Job	Truss	Truss Type	Qty	Ply	PBS\SELMA ENGLISH COUNTRY LH RF			
72510345REP1	A2	Truss	10	1	Job Reference (optional)

UFP Mid Atlantic LLC, 5631 S. NC 62, Burlington, NC, JMP

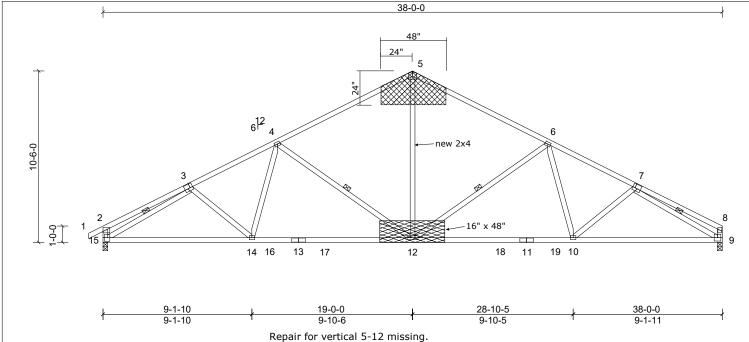
Cut and fit tight a new 2x4 SP or SPF No.2 vertical and attach 1/2" Plywood or 7/16" OSB (APA Rated Sheathing Exposure 1) gussets to both sides of truss as shown with two rows of 10d (.131" x 3") nails spaced 4" oc in all members from each face, driven through both sheets of plywood.
